Southampton to London Pipeline Project

Responses to ExA's Further Written Questions -
Queen Elizabeth Country Park (QE)

Application Document: 8.42

Southampton to London Pipeline Project
Response to the Examining Authority's Further Written Questions – Queen Elizabeth Country Park (QE)

Appendix QE.2.7.2: Access and Right of Way - Addition of Queen Elizabeth Park Access (Sheet 35 & 106)

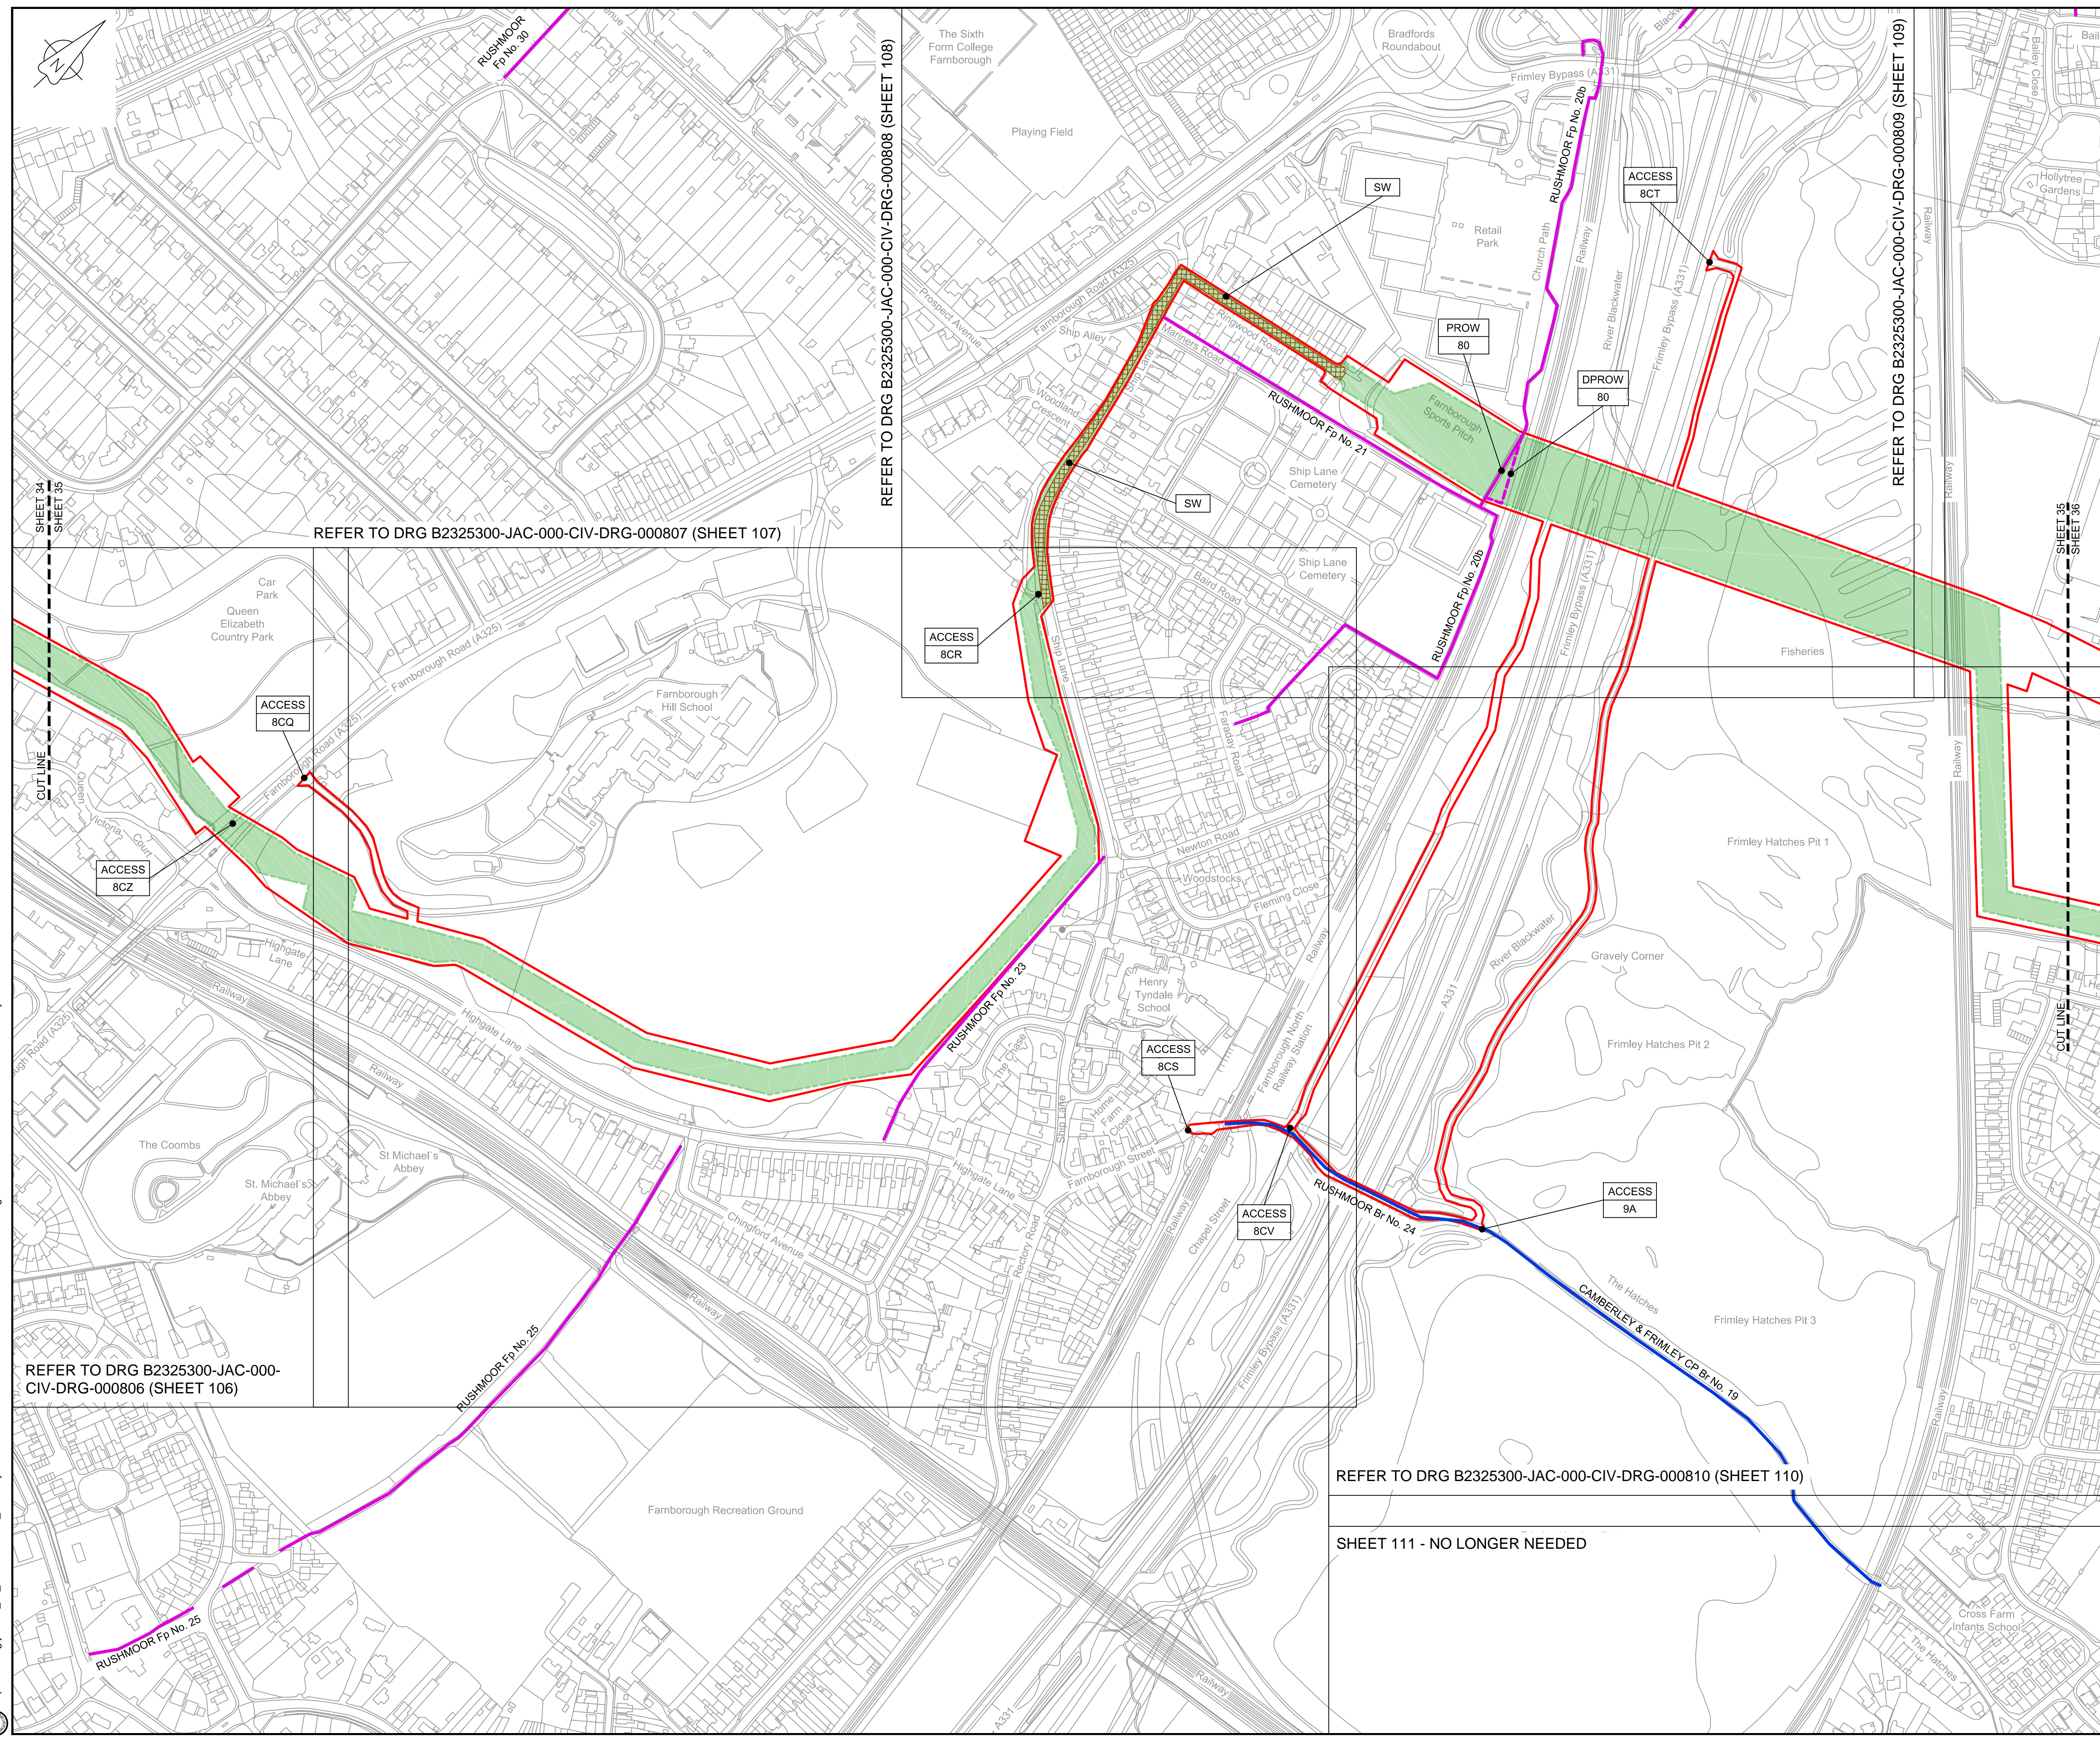
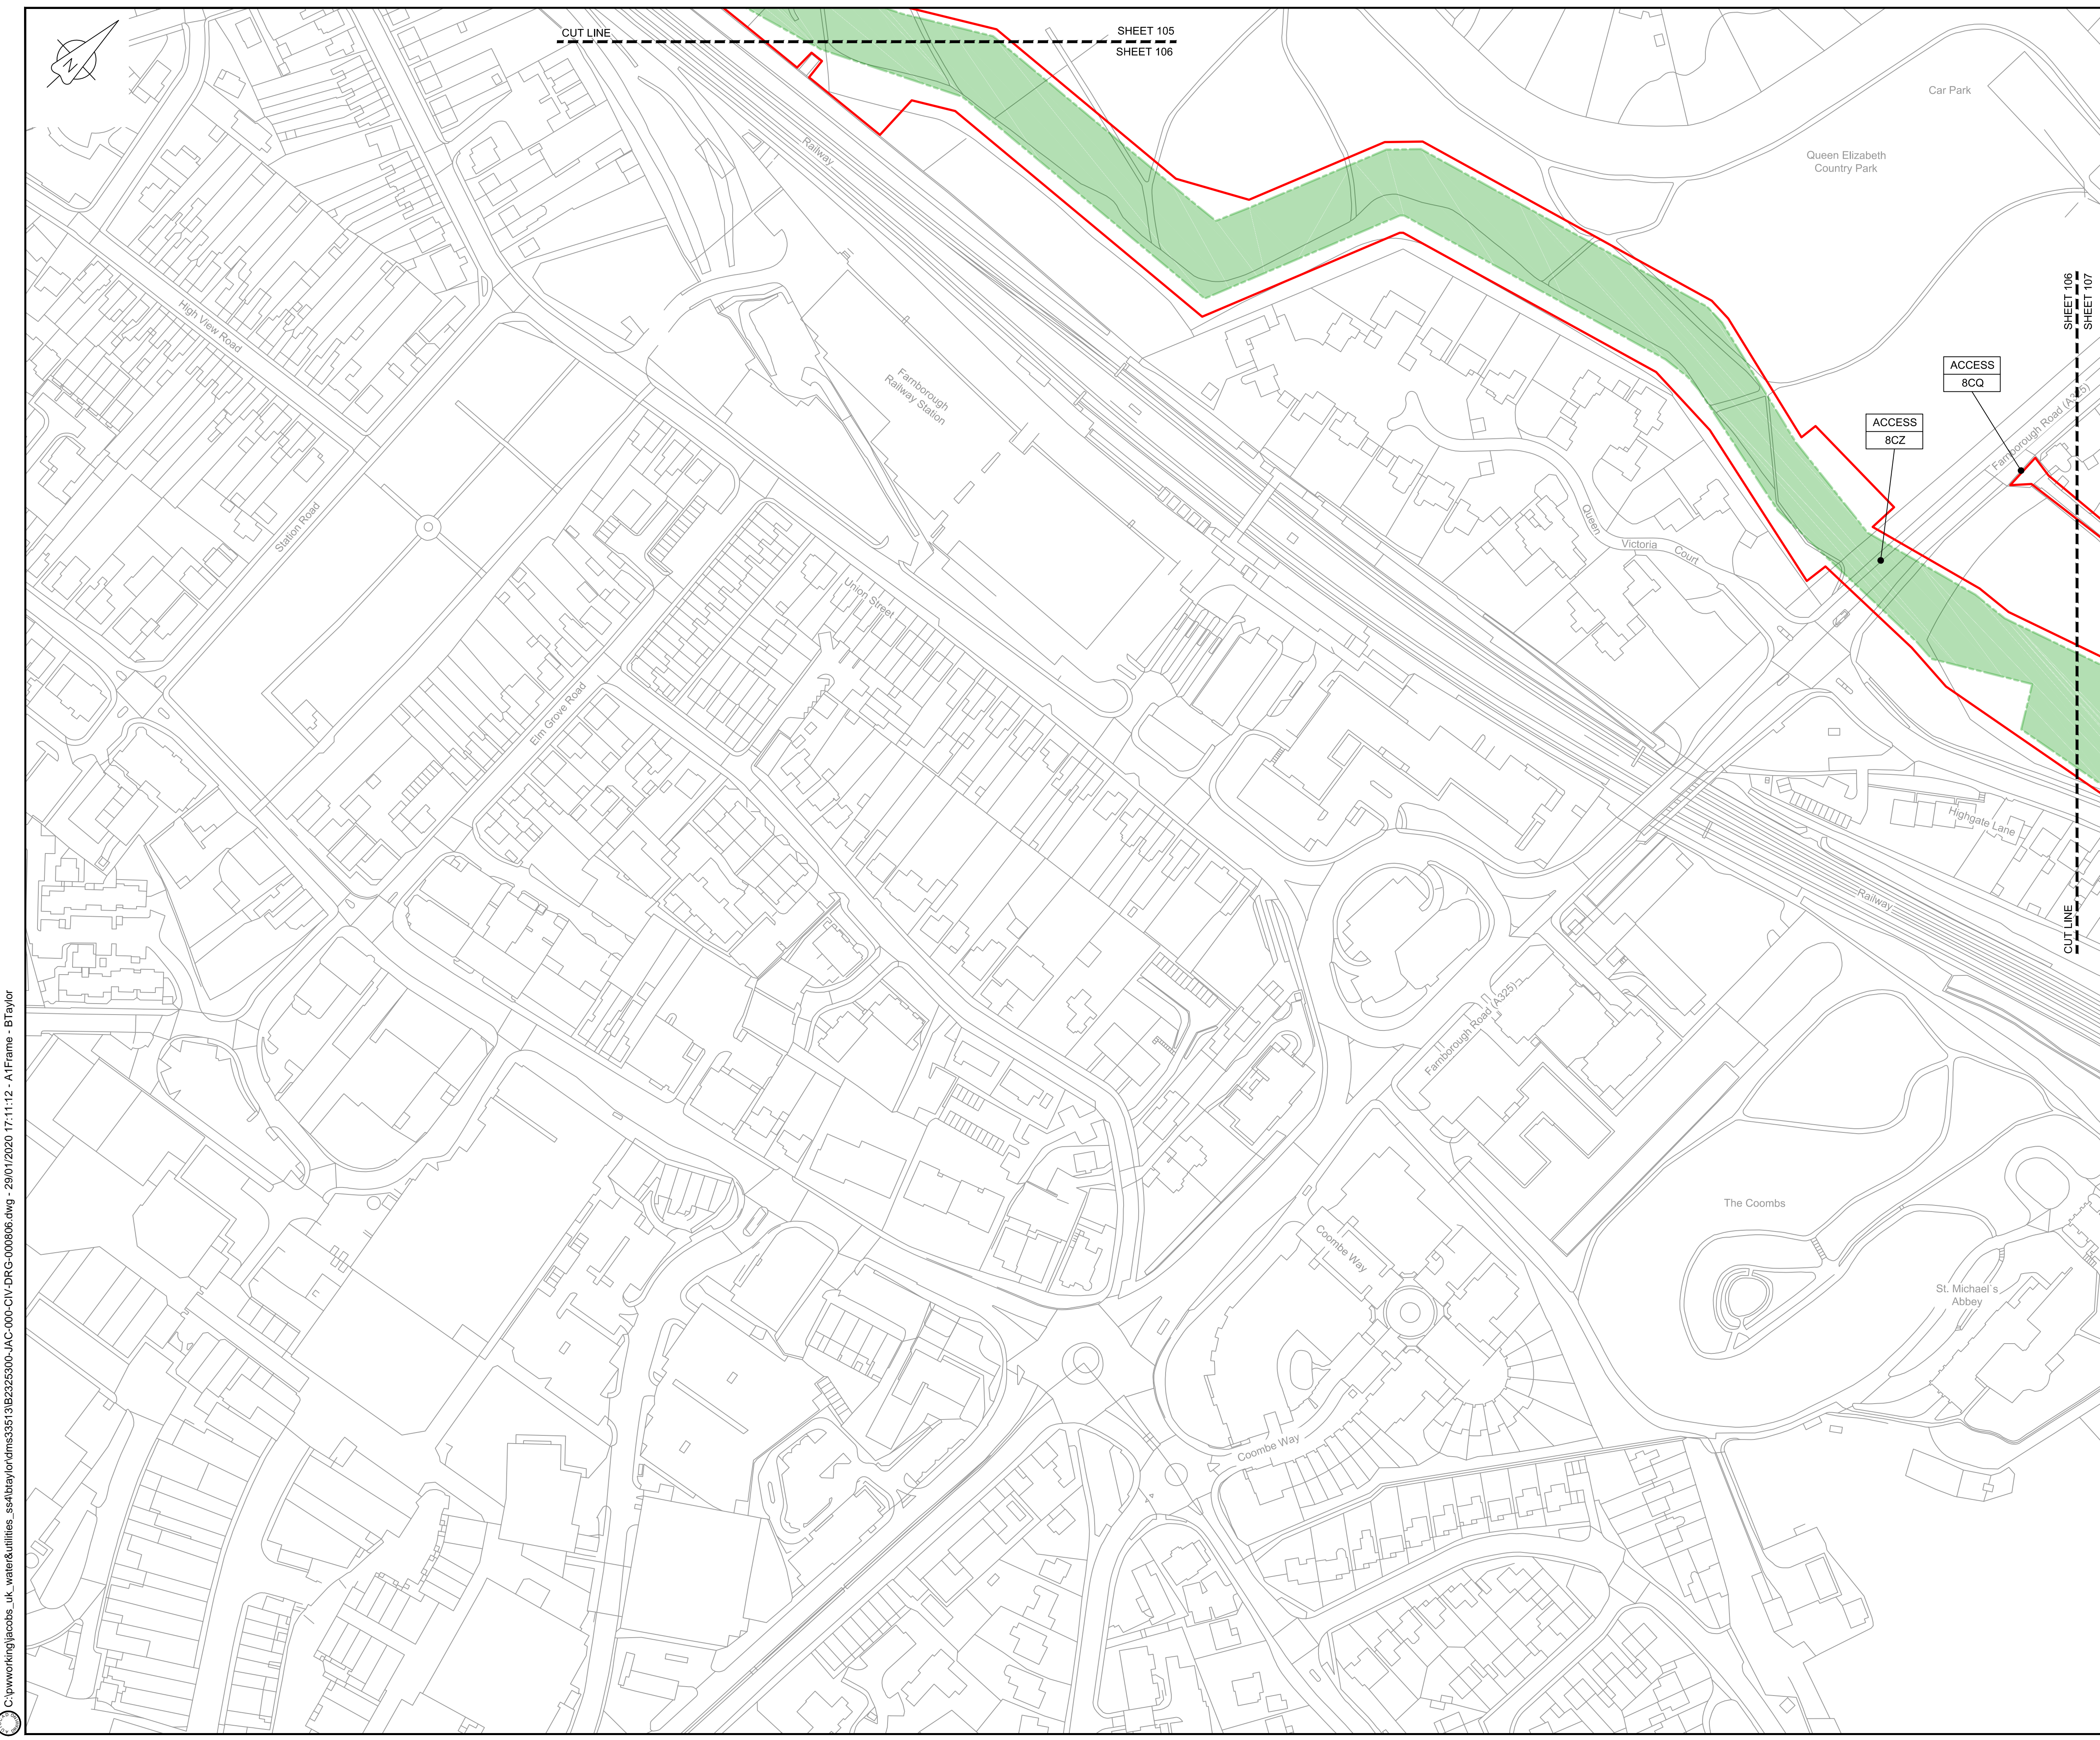
ExQ2	Question:	Applicant response to Question:
QE.2.7	<p>Figure 1.5 of the Applicant's responses to Other Parties submitted at D3 [REP3-017] indicates the proposed temporary access from Farnborough Road to the auger drill compound in Queen Elizabeth Country Park. This proposed temporary works access has been added to the dDCO [REP3-006] but is not shown on the relevant Access and Public Rights of Way or Works Plans.</p>	<p>1.1 The Applicant confirms that the proposed temporary access (Work No 8CZ) from the A325 – Farnborough Road to the auger bore area is now shown on the Work Plans and Access and Public Rights of Way Plans (See Appendix QE.2.7.1 and QE.2.7.2).</p>

C02	09/09/19	SHEETS 10, 11 AND 54 REVISED TO WITHDRAWN A29 SUB-OPTION	BT	JA	ND	NJ
C03	29/11/20	UPDATED FOLLOWING LAND OWNER DISCUSSIONS AND TO ADDRESS FWG2s	BT	JA	ND	RS
Rev	Rev. Date	Purpose of revision	Drawn	Checked	Rev'd	Appr'd
